ADDENDUM NO. [1]

Date: March 26, 2018

**RE: WITC – SUPERIOR CAMPUS
PLUMBING AND HVAC MAINTENANCE
600 N 21ST STREET
SUPERIOR, WI 54880
HSR PROJECT NO. 17063-2 & 7**

**FROM: HSR Associates, Inc
100 Milwaukee Street
La Crosse, WI 54603
(608) 784-1830**

M101R

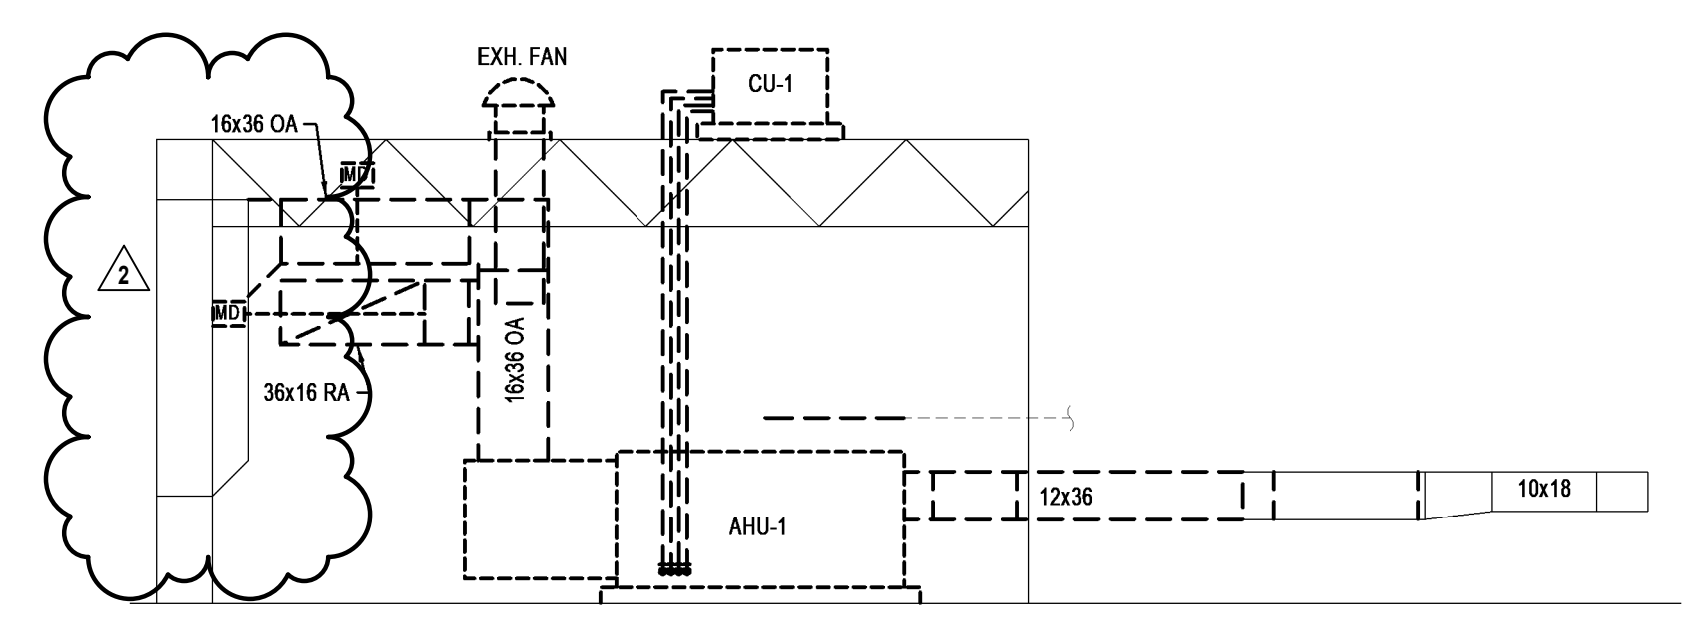
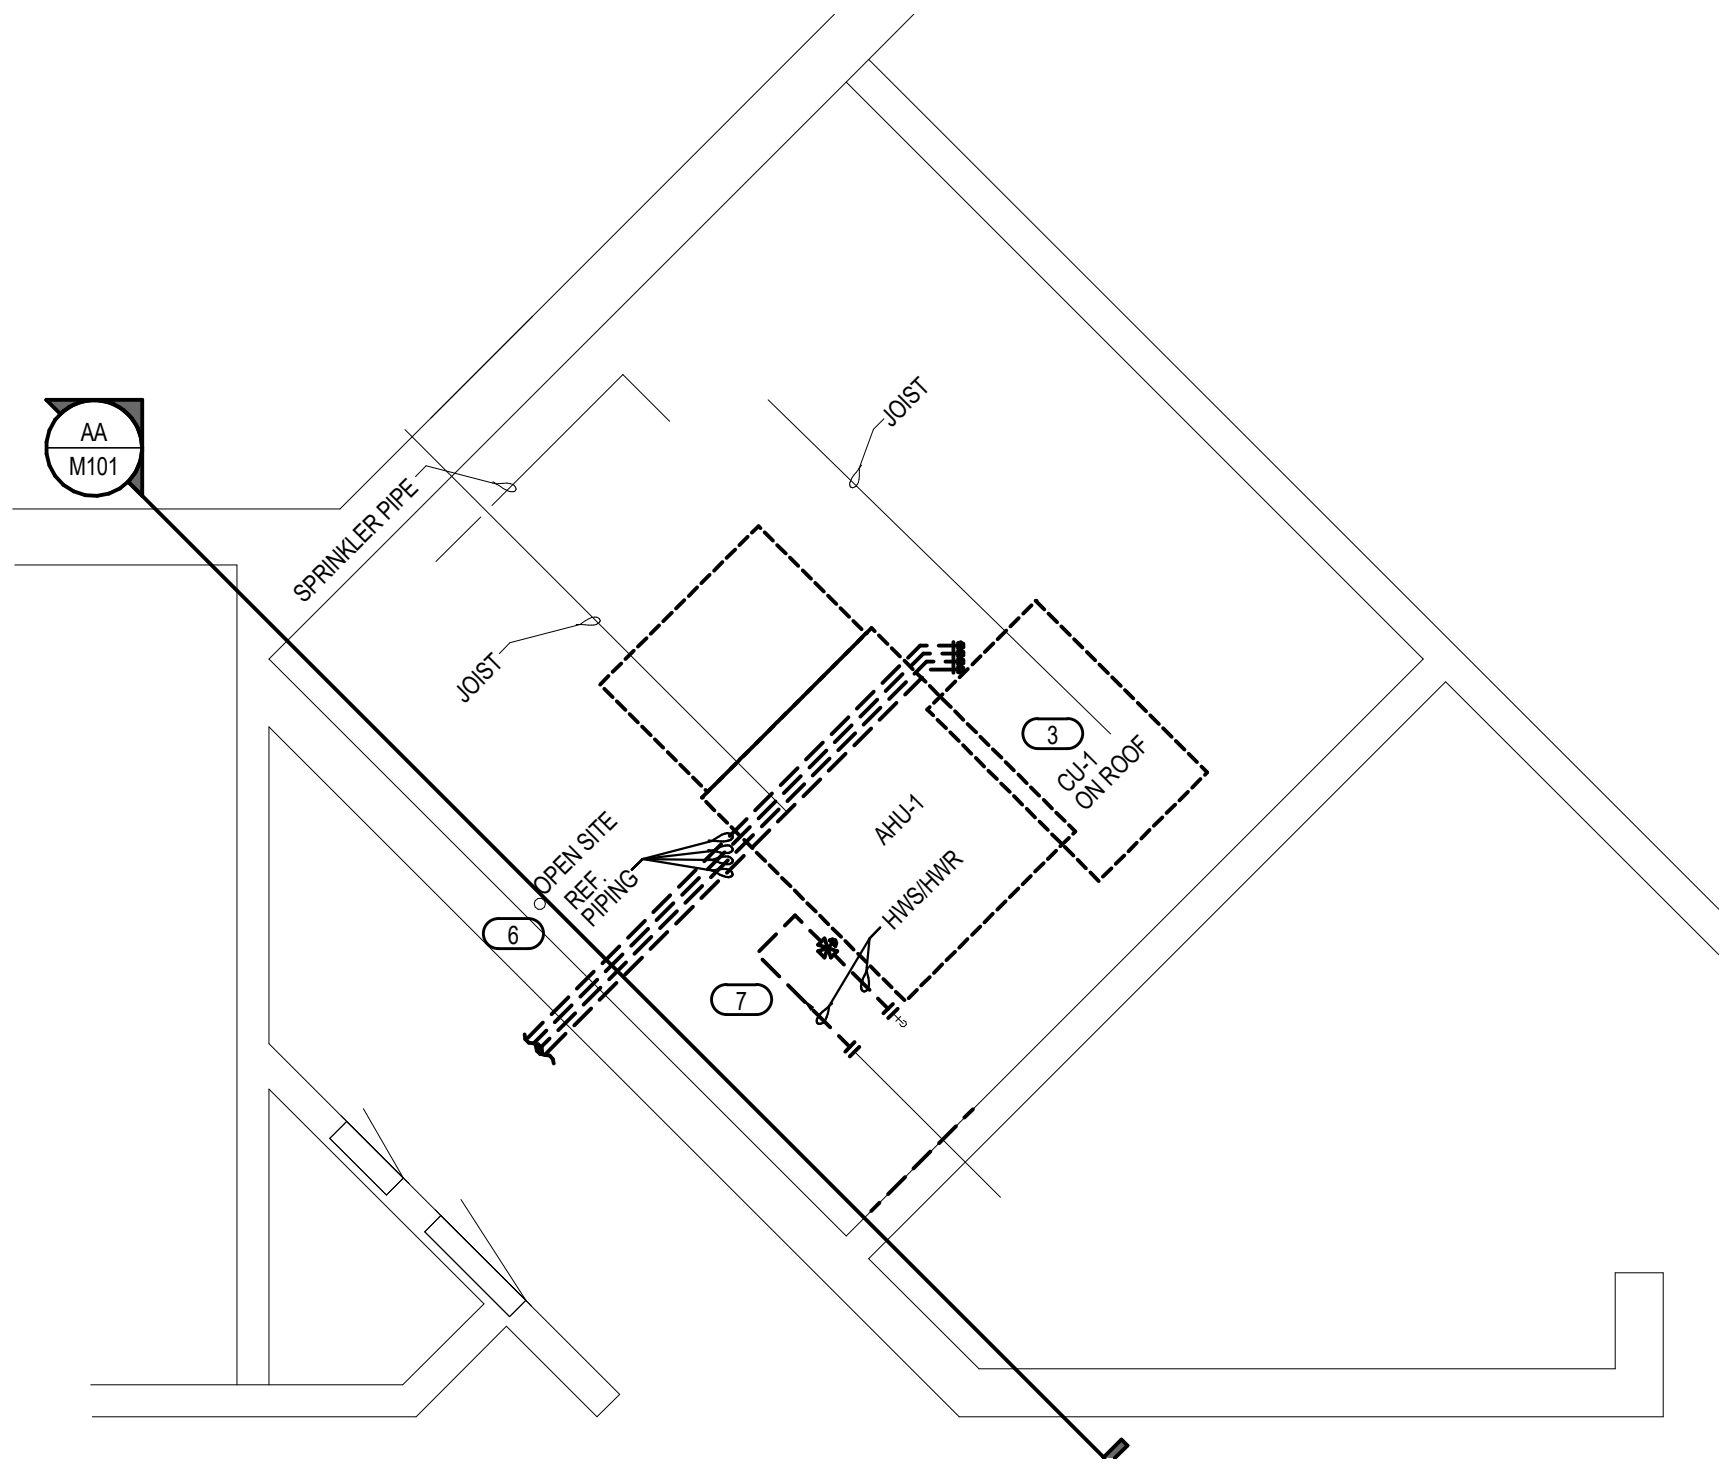
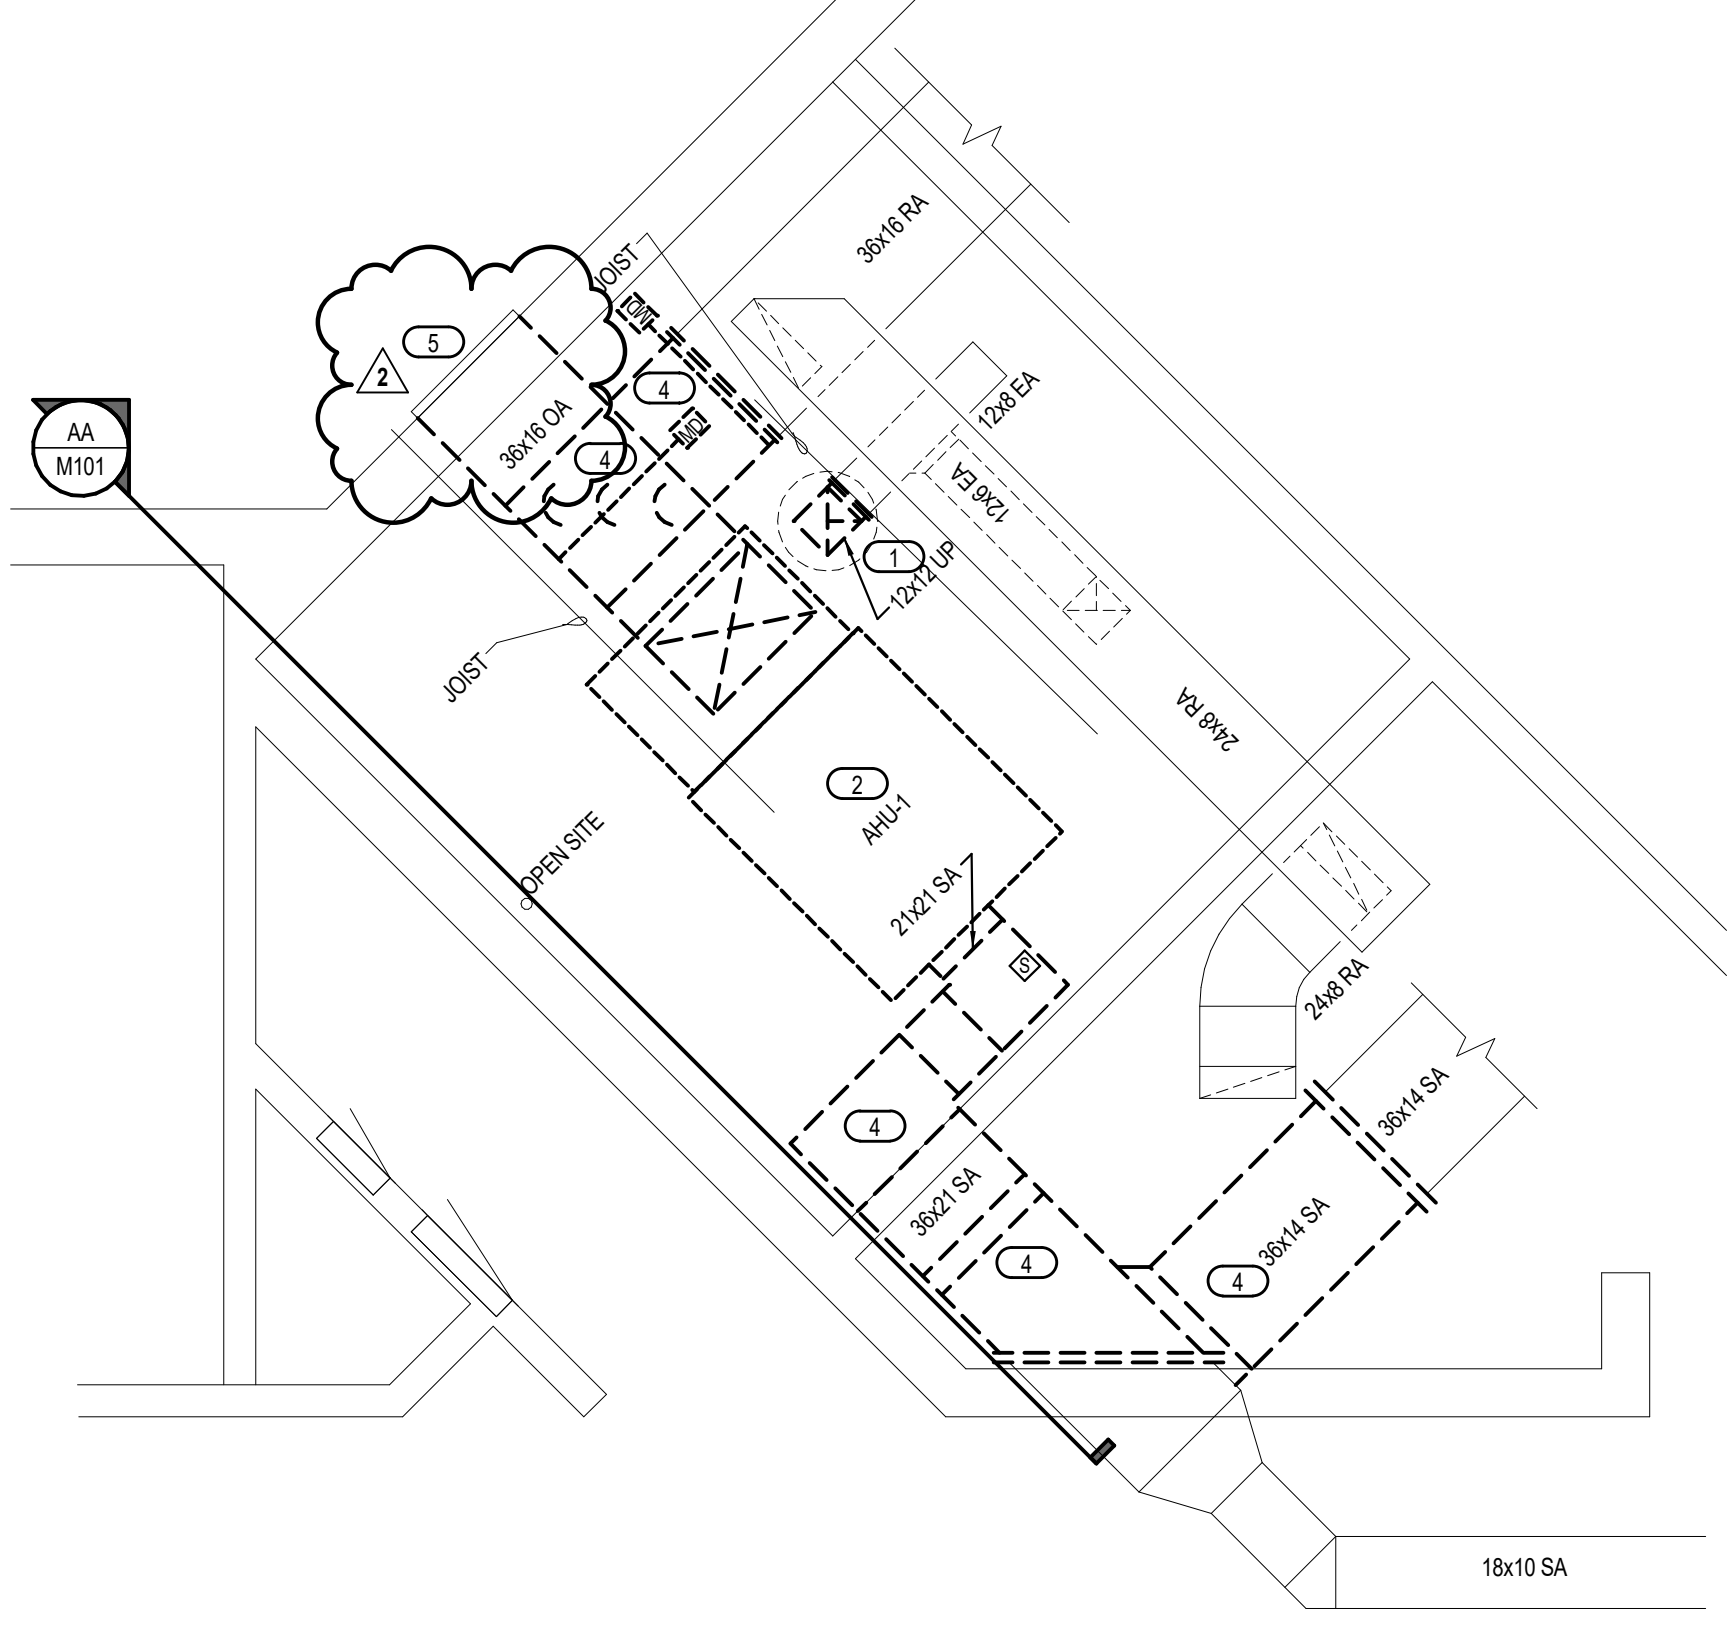
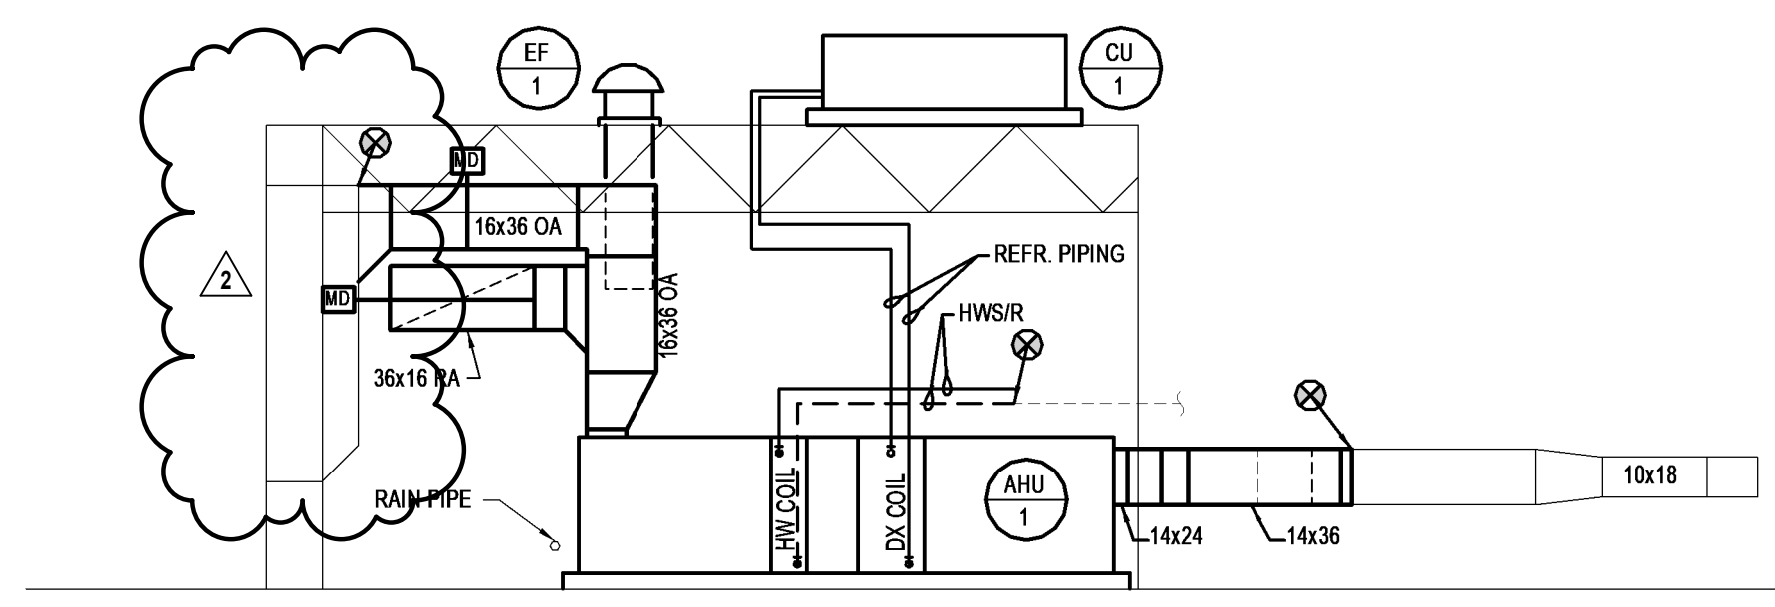
- a. Keynote 2: Delete “reuse existing water cooler”. Water coolers will be new and installed in a high/low fashion.
17. Sheet M101R MECHANICAL DUCTWORK AND PIPING PLANS – AHU 30 x 42 attached hereto

- a. Revisions clouded on Drawing.
18. Sheet M501 MECHANICAL DETAILS AND SCHEDULE
 - a. Remove the Louver Schedule in its entirety.
19. Sheet E001 ELECTRICAL NOTES, LEGENDS & ABBREVIATIONS
